This bulletin supersedes Technical Service Bulletin (TSB) 08-068-22, date of issue March 26, 2022, which should be removed from your files. All revisions are highlighted with **asterisks**** and include an updated build date.**

Global Telematics Box Module (TBM2) Firmware Over The Air Software Version Updates

2022 (MP) Jeep Compass

Fig. 1
Error Message

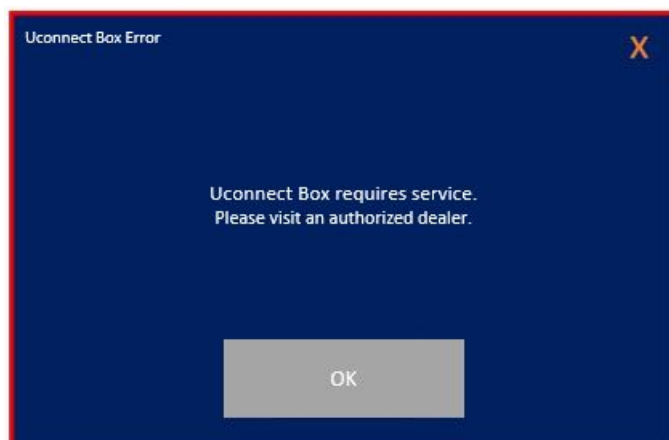
- Message displayed on the radio screen, "Uconnect Box requires service. Please visit an authorized dealer." (Fig. 1) .
